STAFF REPORT
KETCHUM PLANNING AND ZONING COMMISSION
SPECIAL MEETING OF MARCH 23, 2021

PROJECT: 128 Saddle Road Townhomes

FILE NUMBERS: P21-013 & P21-012

APPLICATION: Design Review, Townhouse Subdivision Preliminary Plat, and Phased Development Agreement

VALLEYWOOD DR. RIGHT-OF-WAY IMPROVEMENT PLAN
128 SADDLE ROAD TOWNHOUSES
LOCATED WITHIN SECTION 7, T.4 N., R.18 E., B.M., CITY OF KETCHUM, BLAINE COUNTY, IDAHO
PREPARED FOR 128 SADDLE ROAD LLC / ROBERT PARKER

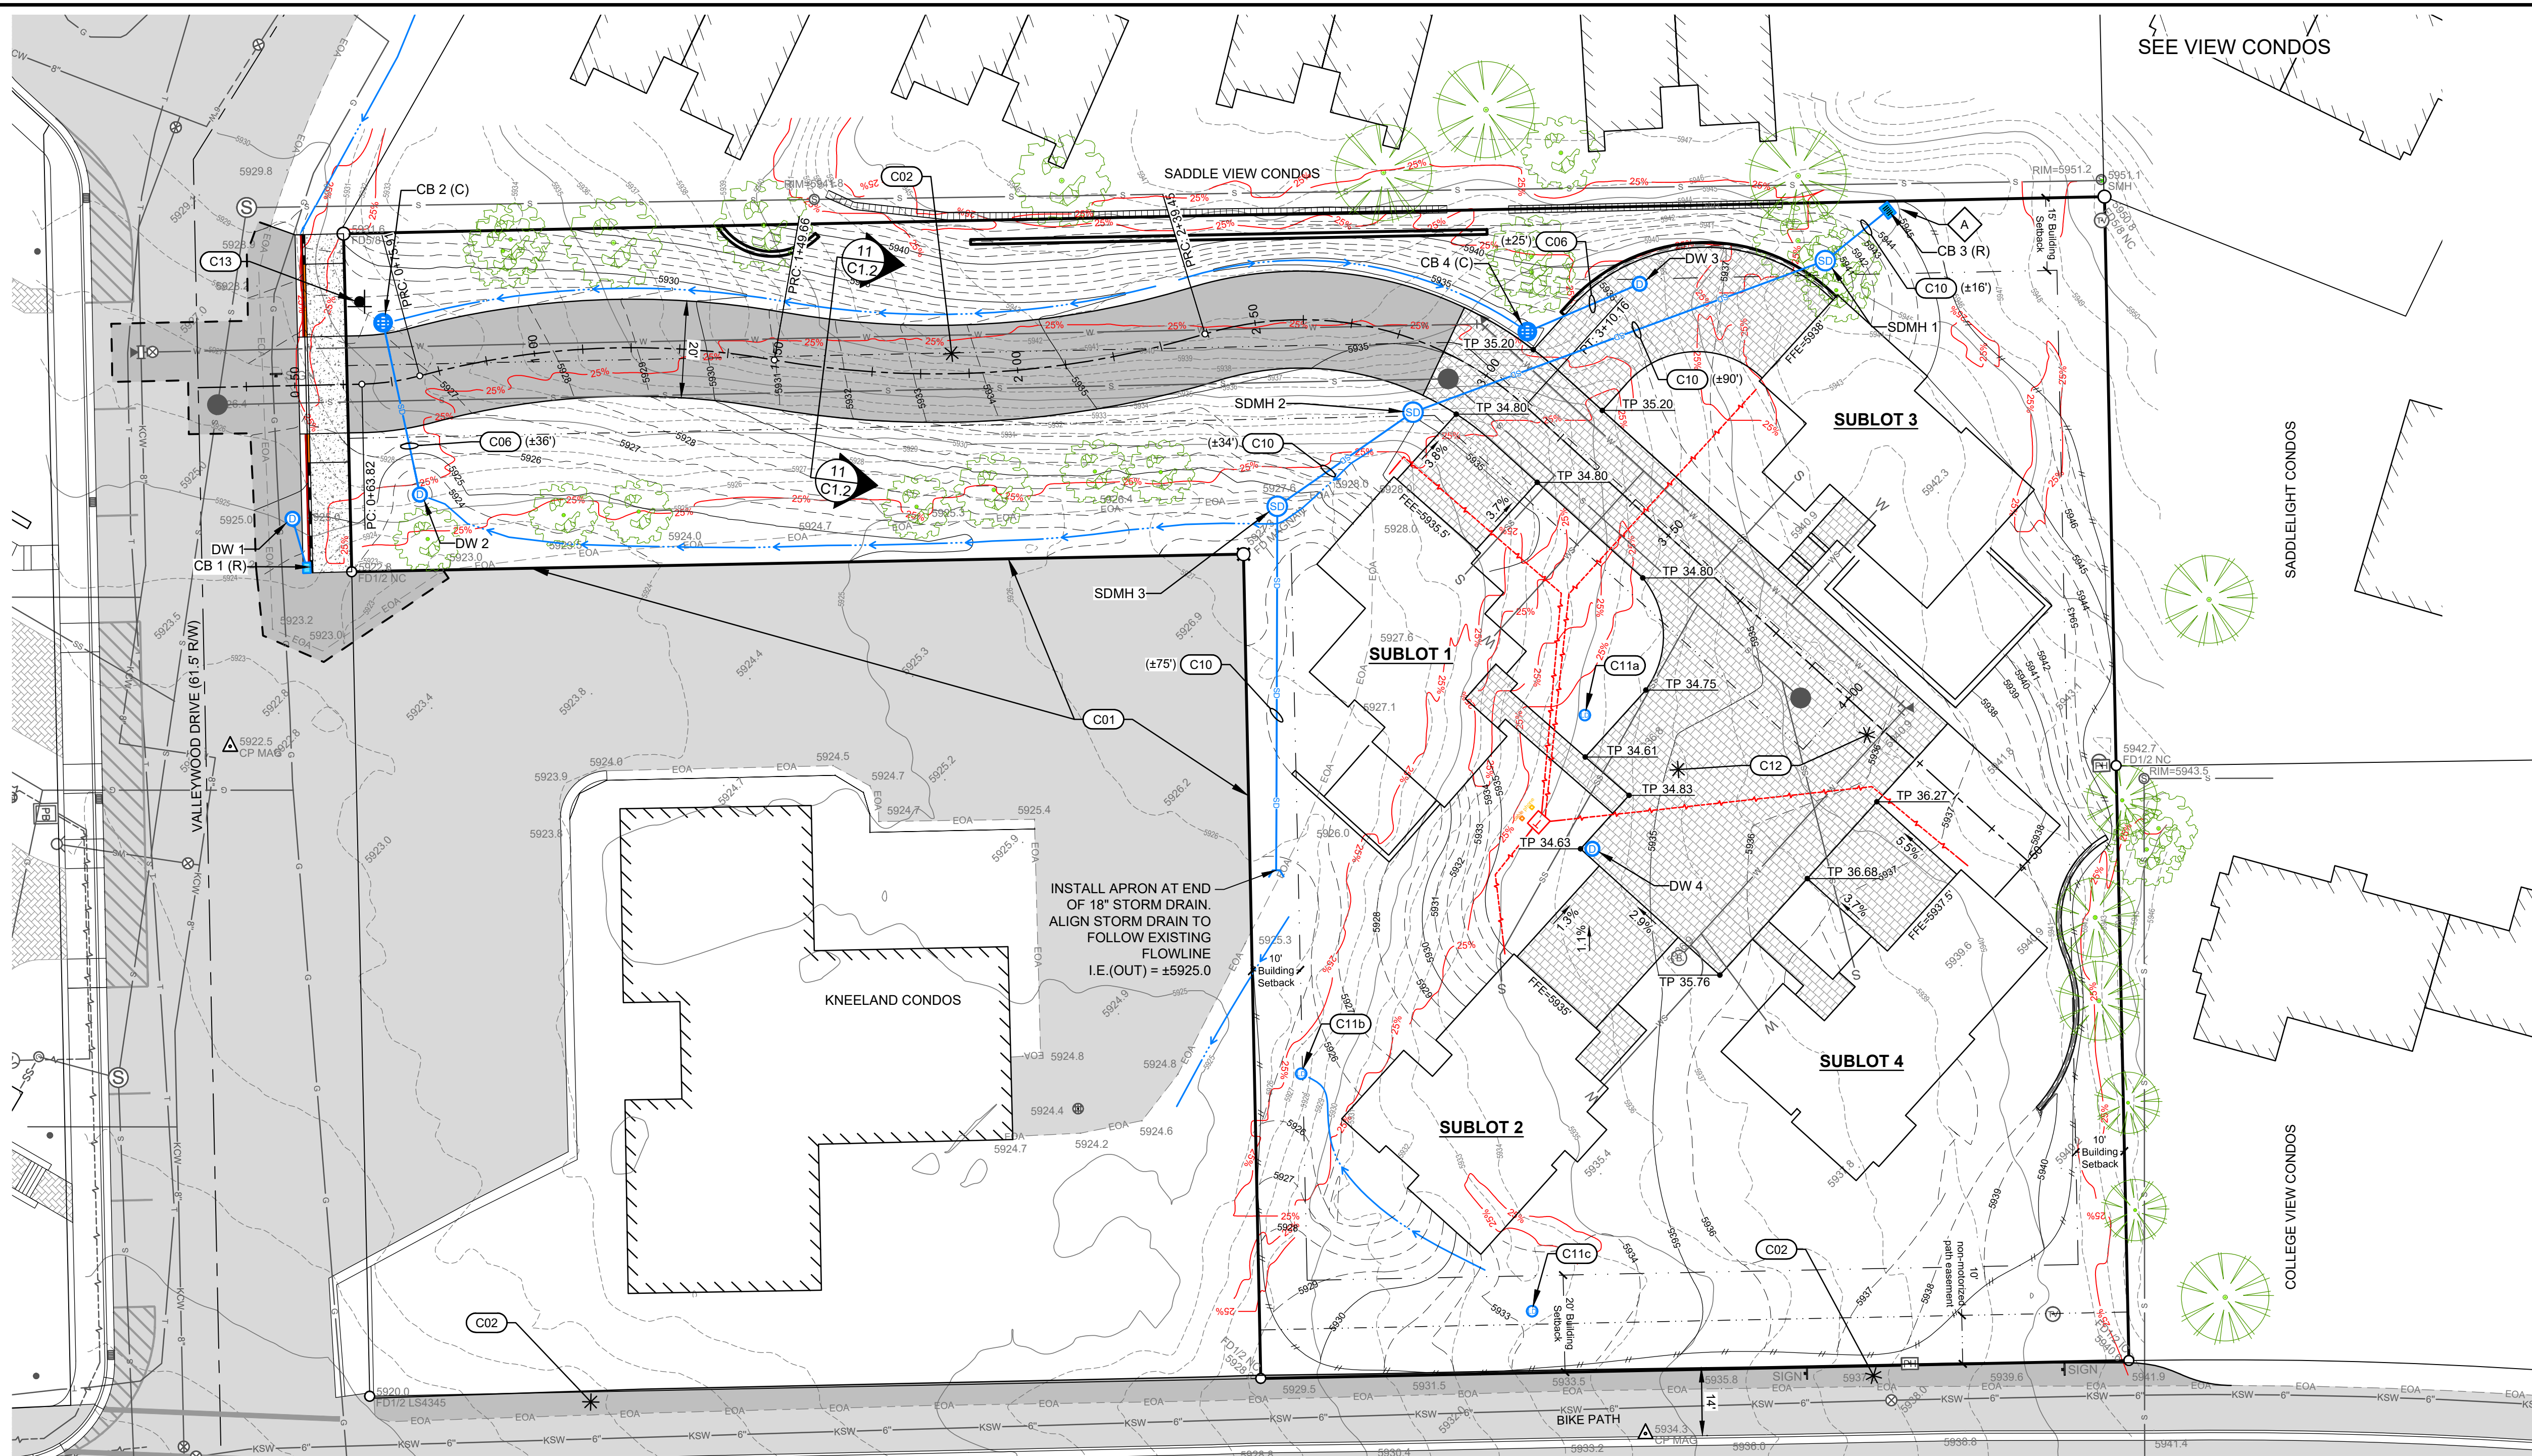
Findings	The project qualifies as a substantial improvement and the developer is required to install sidewalks to city right-of-way standards. As indicated on Sheet C1.0 of the project plans, the applicant will install an 8-foot-wide sidewalk along Valleywood Drive. As indicated on Sheet C1.1, the applicant will improve the bike path along the property's Saddle Road frontage. These improvements include widening the bike path to 14 feet. These improvements will extend west along the Kneeland Condominiums' frontage. The city will pay for this bike path improvement extension, but the bike path improvements shall be installed concurrently by the same contractor. Final civil drawings for all associated ROW improvements shall be submitted with the building permit application to be verified, reviewed, and approved by the City Engineer and Streets Department prior to issuance of a building permit for the project. See Table 1 for comments and conditions from the City Engineer & Streets Department.
